# Regional Review Finding Development of Regional Impact

**RE:** Development of Regional Impact (DRI) Review

**Name of Proposal:** Sylvan Mixed-Use DRI 4330  
**Submitting Local Government:** City of Atlanta  
**Date Opened:** October 1, 2025      **Date Closed:** October 22, 2025

**Description:** A DRI review of a proposal to develop a mixed-use project with 3,032 multi-family apartments, a 300-room hotel, 20,000 SF of civic space, 257,050 SF of office space, and 147,255 SF of retail/restaurant space on a 13.87-acre previously developed site generally located near the Oakland City MARTA station at 1313 Sylvan Road in the City of Atlanta in Fulton County.

SHEET NUMBER:  
**DR1.0**

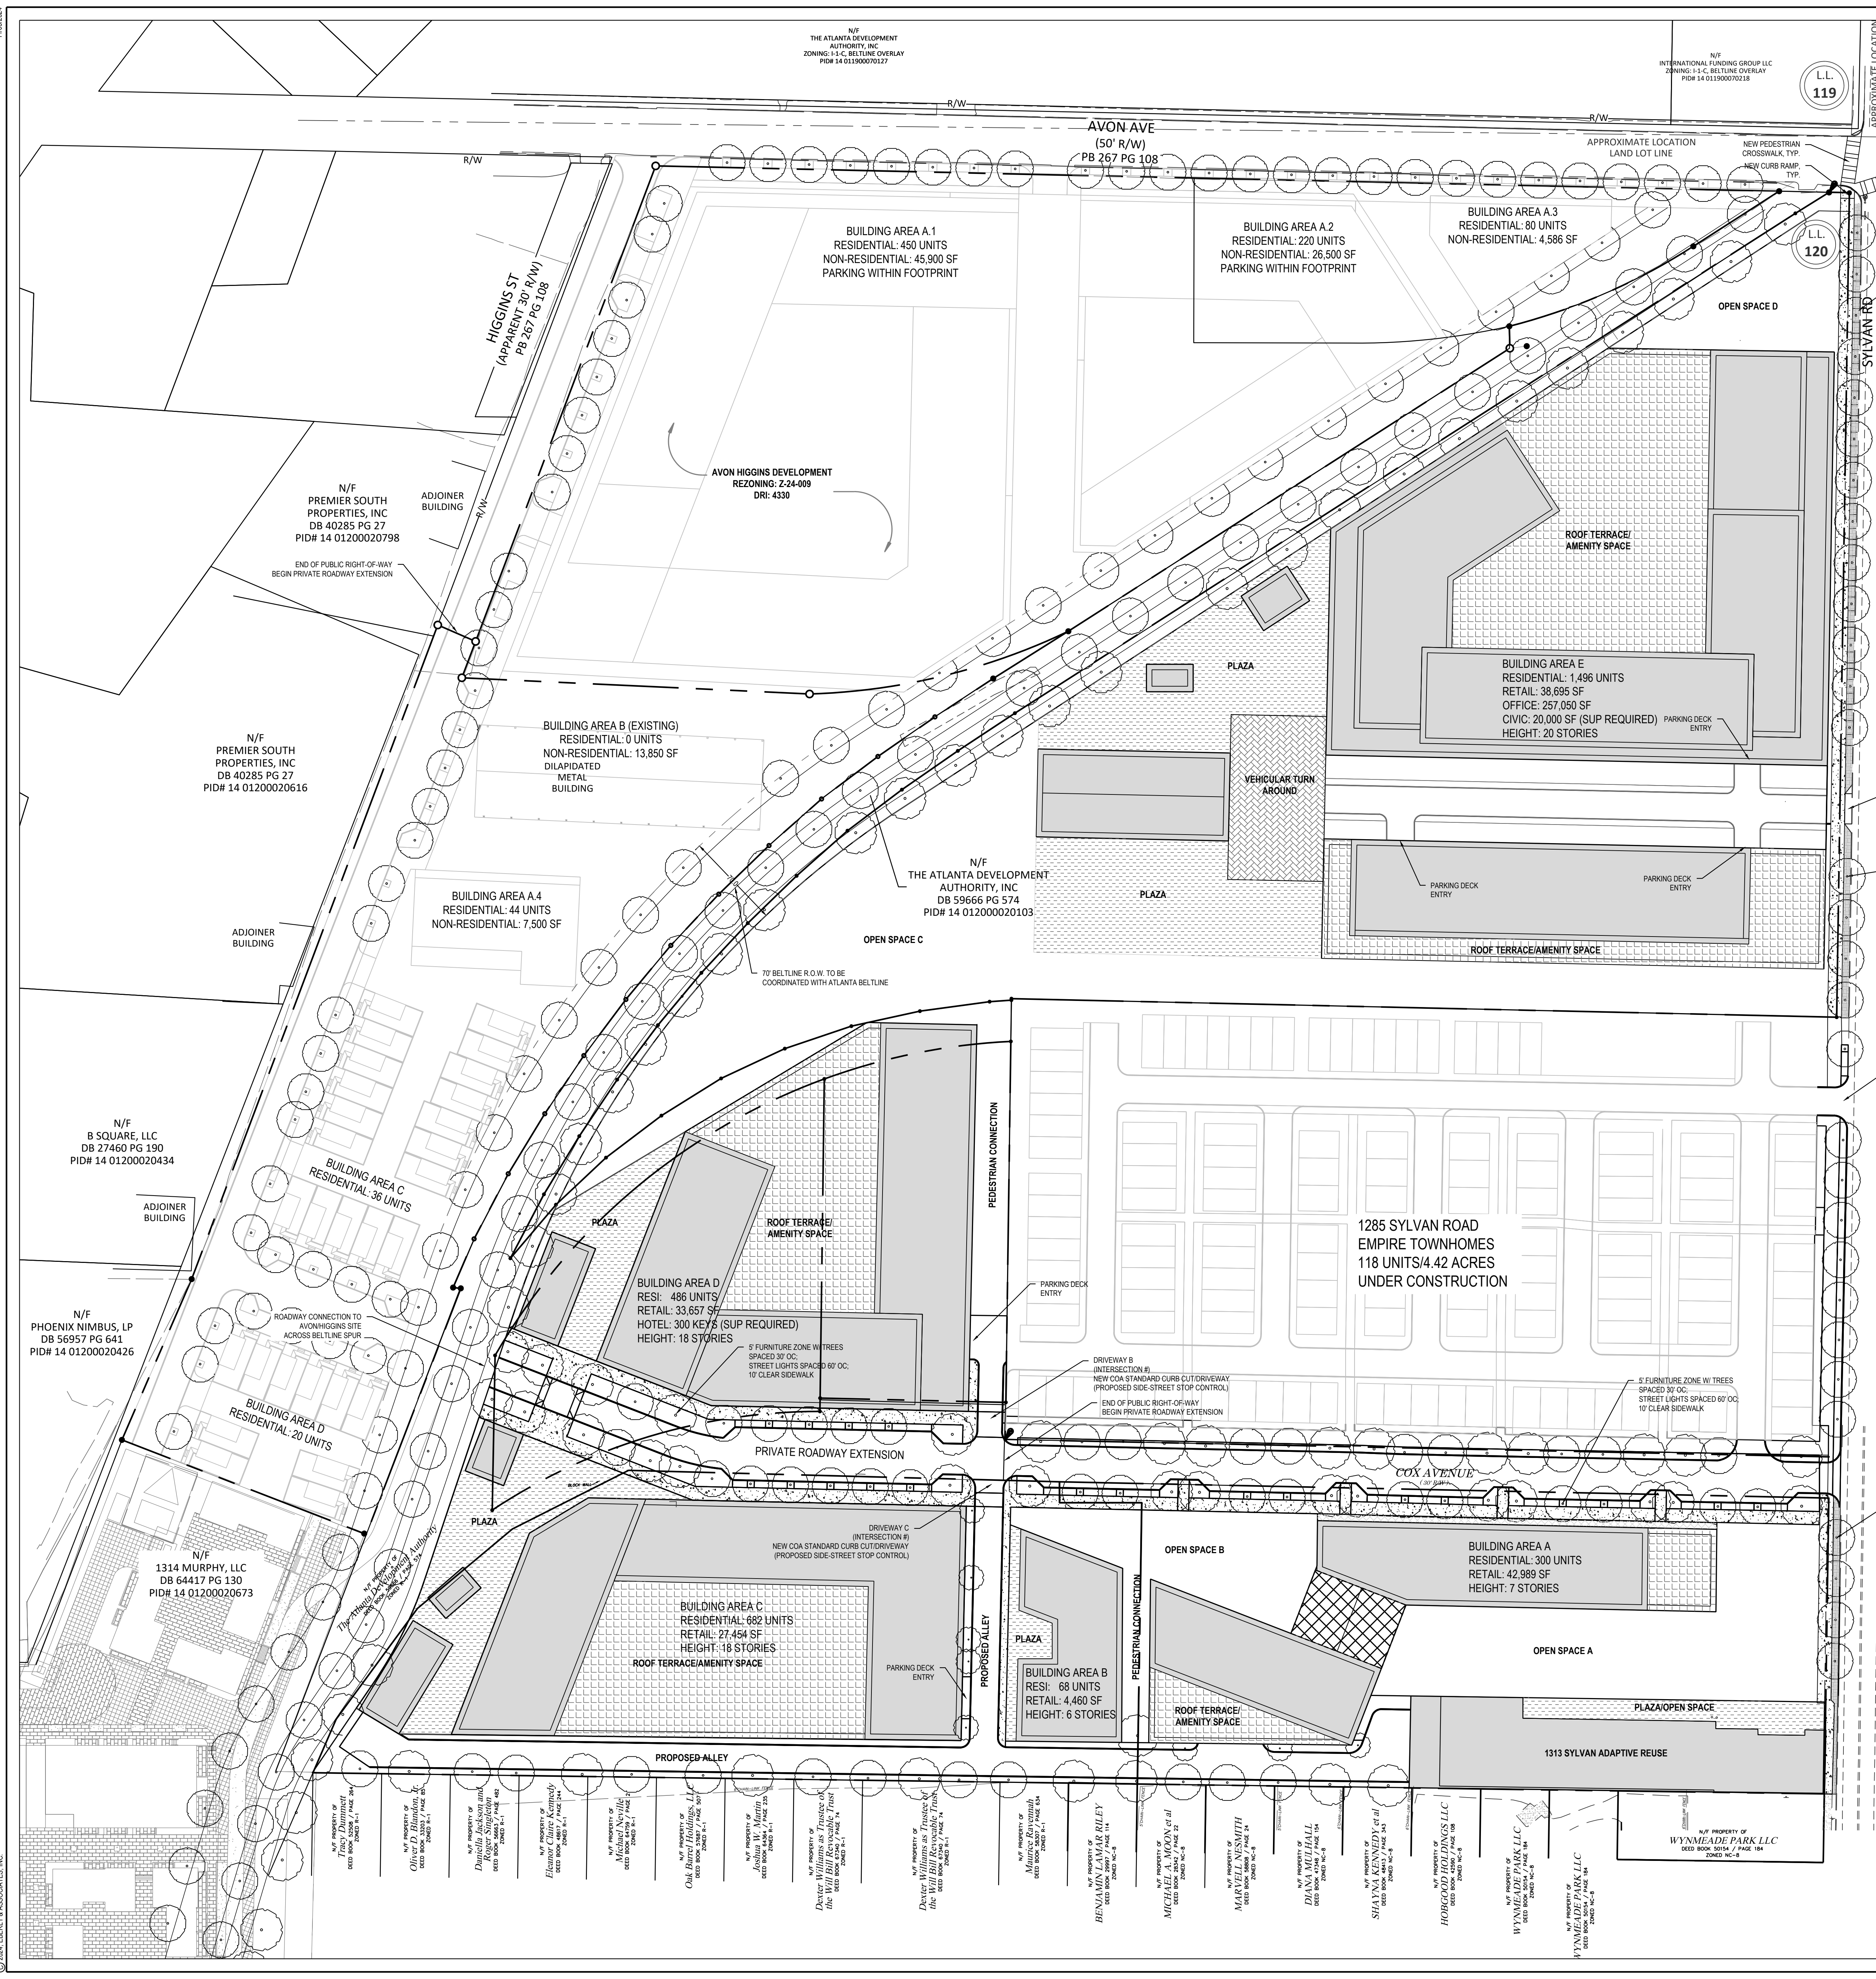
Neither the USGS coverage for the project area nor the submitted site plan show any perennial or intermittent streams on the project property. Any unmapped streams on the property may be subject to the City's stream buffer requirements.

Sidewalks are wide and provide good pedestrian walking conditions. The site does not show crosswalks and should show where there are safe crossing locations. There are no bike lanes shown within site.

No.
